AMENDMENT NO. 1 MAY 2013 **TO** **IS 11570 : 1985 CRITERIA FOR HYDRAULIC DESIGN OF** **IRRIGATION INTAKE STRUCTURES**

FIG. 7 DIAGRAMS FOR DETERMINING OPTIMUM SUBMERGENCE

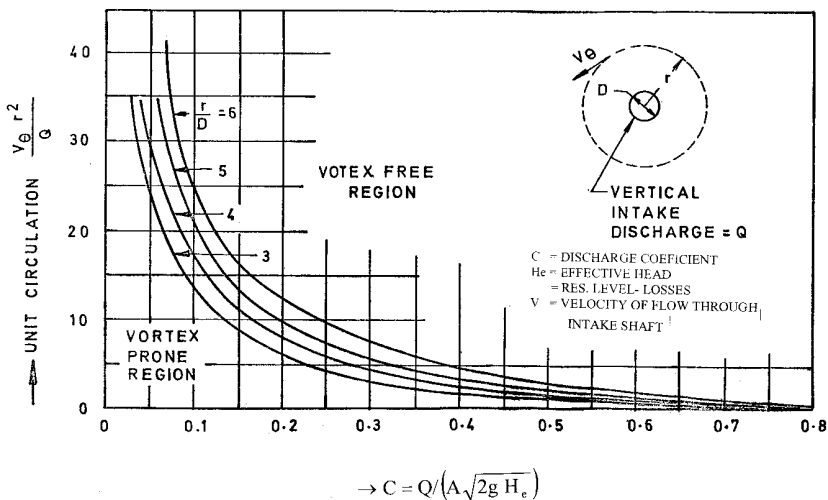
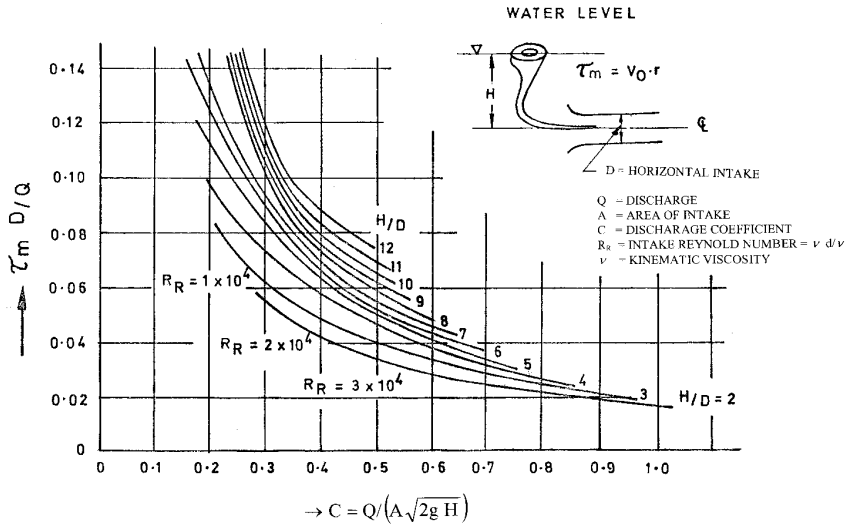
(Page 19 and 20, Fig. 7) — Substitute the following for the existing figure:

7A FOR VERTICAL INTAKES

7B FOR HORIZONTAL INTAKES

FIG. 8 BELL-MOUTH DETAILS OF RECTANGULAR OPENING

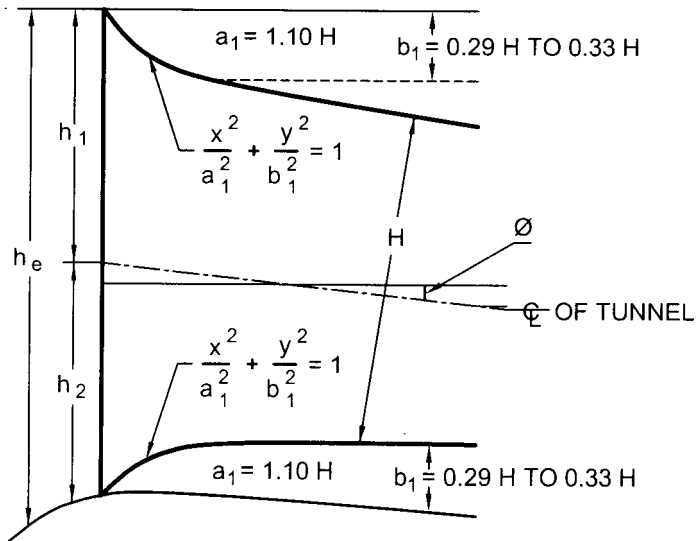
(Page 21, Fig 8) — Substitute the following figure for the existing:

(Page 22, Fig 8) — Substitute 'b_e' for 'h_e'

8A ELEVATION
